Re: Graythwaite Sydney Church of England Grammar School
Addendum 1 to Integrated Water Management Plan Concept Application

Please accept this letter and attached revised plan, number SY100450-C1.02 - Rev. H, as an Addendum to our original report of 6th October 2010 (as updated on 26th November 2010) titled "Integrated Water Management Plan..... To The Concept Application (Stage 1, 2, & 3)".

CONCEPT STORMWATER MANAGEMENT PLAN

B1 Q.A. Check AUG 10 AM 1:500 C1.02 H SY100450

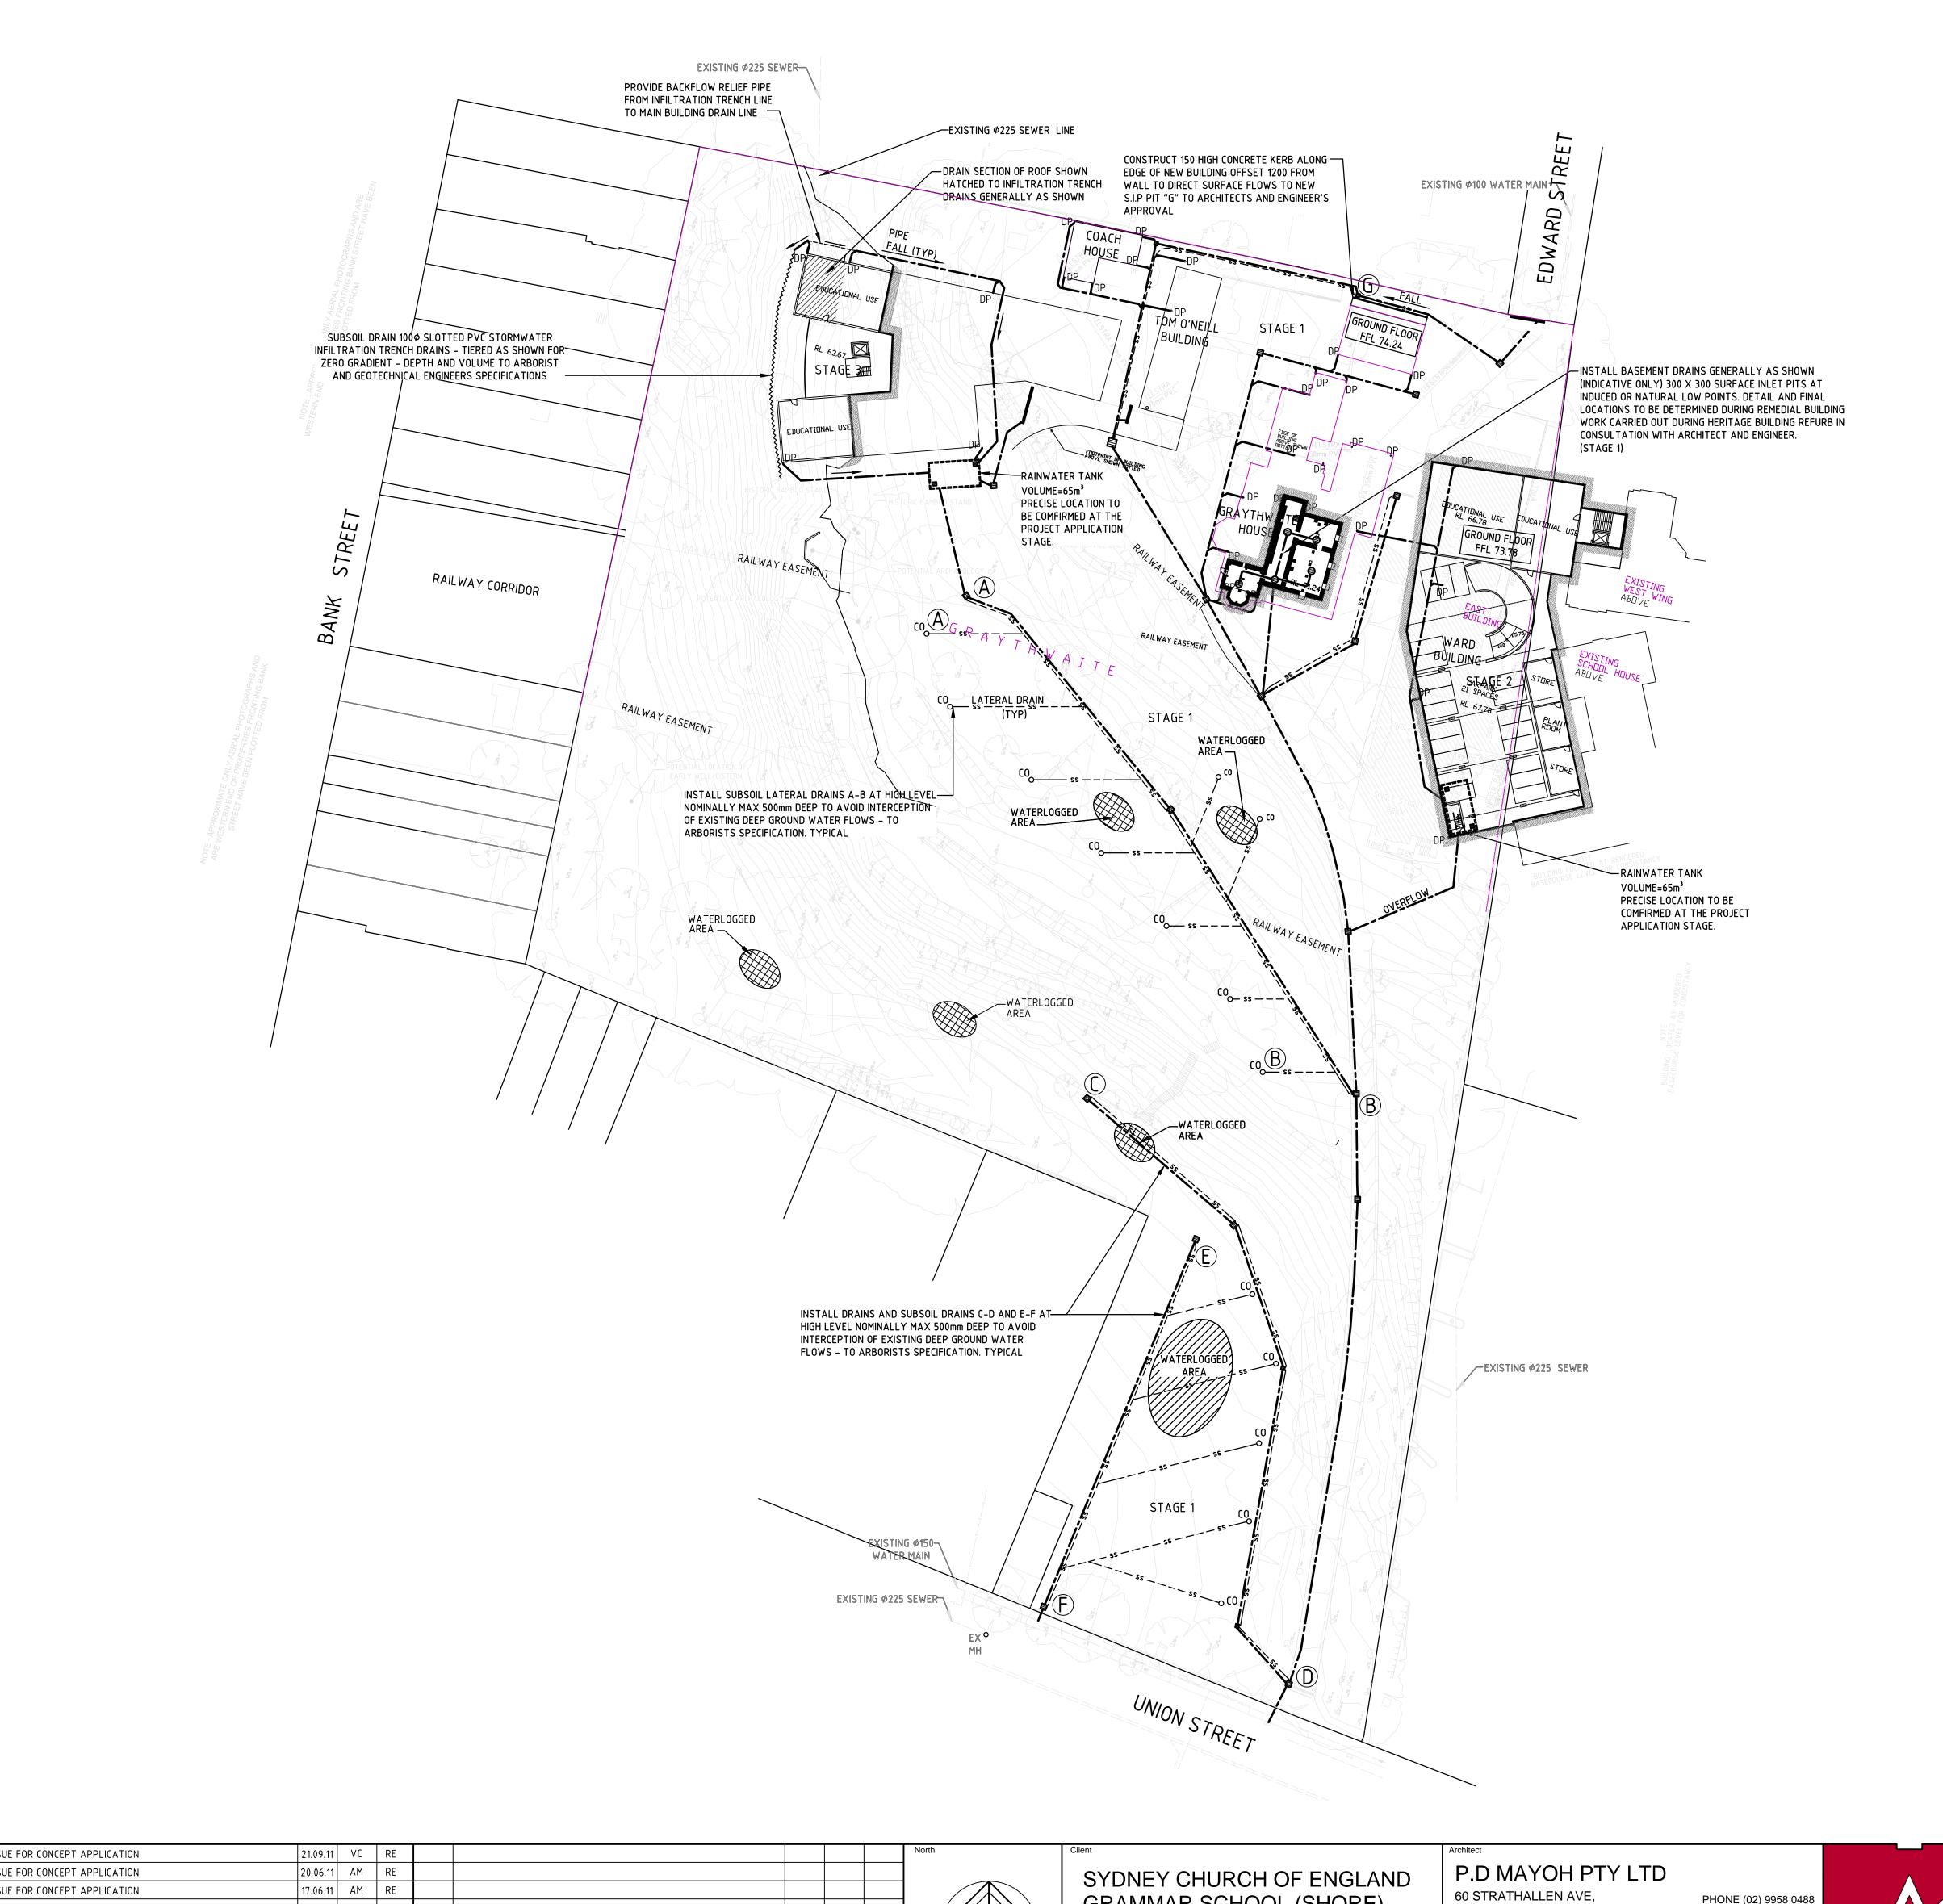
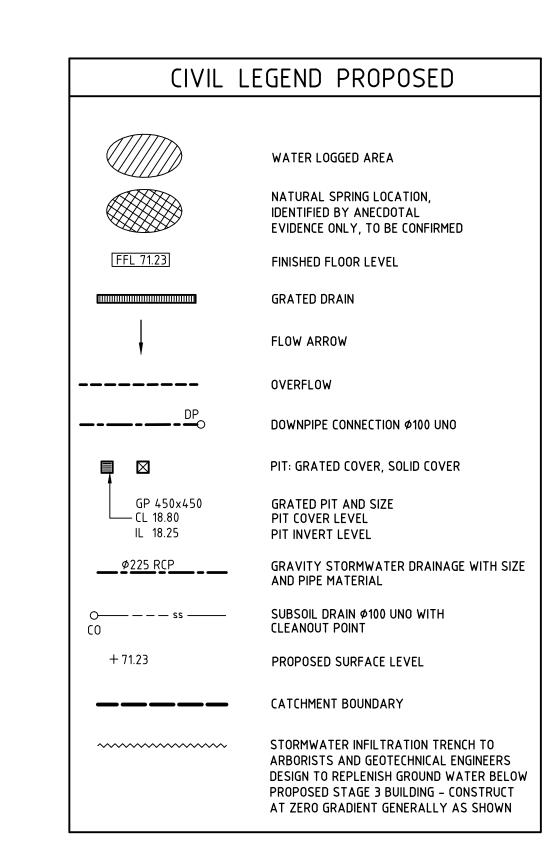
Council has indicated that the roof and subsoil stormwater drains proposed to Graythwaite House, Tom O'Neill Centre and the Coach House are not supported by Council and should therefore be deleted from the proposed development proposal.

We therefore reaffirm our recommendation to incorporate roof stormwater capture and transport away from these buildings and a groundwater intercept drain system (subsoil drain) to specific building curtilage areas as proposed in the stormwater management plan.

The revised concept stormwater management plan provides for the removal of existing building roof water and diversion of groundwater flows around the heritage buildings to facilitate and ensure the longer term function and protection of these historically valuable buildings.

Council has suggested that several identified ephemeral springs on the site should be retained and possibly adapted for creation of artificial ephemeral wetlands as part of the landscape plan for the site.

The revised stormwater management plan therefore incorporates high level subsoil drainage of these springs and other waterlogged zones to a nominal maximum depth of 500mm.

Council has indicated that the perceived loss of ground water flows caused by interception of the proposed new building structures cannot be supported due to the impact upon the pristine catchment conditions enjoyed over the past 150 years.

Notwithstanding the above, and in response to concerns relating to reduced ground water flows along the western boundary of the site, the revised stormwater management plan in liaison with the project arborist now incorporates a strategic section of ground water infiltration in the proposed Stage 3 area of the project in order to minimise the perceived impact of reduced ground water flows to the existing tree line at this location.

- 1. Roof stormwater and ground water flows in the area of the existing heritage buildings should be controlled with a system of roof, surface and sub-surface drains to prevent continued ingress of water into these historic buildings

- 2. Stormwater from future proposed buildings shall incorporate water harvesting principles with reuse to landscape areas and toilet flushing
- 3. Installation of shallow subsoil drains within open areas identified as waterlogged or springs shall be limited to upper level ground water interception and drainage i.e. <500mm deep, thus ensuring that the deeper ground water flows remain generally unimpeded while facilitating the safe use and maintenance of the grounds</p>

- 4. A portion of roof stormwater emanating from the proposed Stage 3 building shall be drained into a new ground infiltration trench drain located immediately to the west of the new building to provide for reintroduction of ground water within the 'groundwater shadow line' of the building footprint
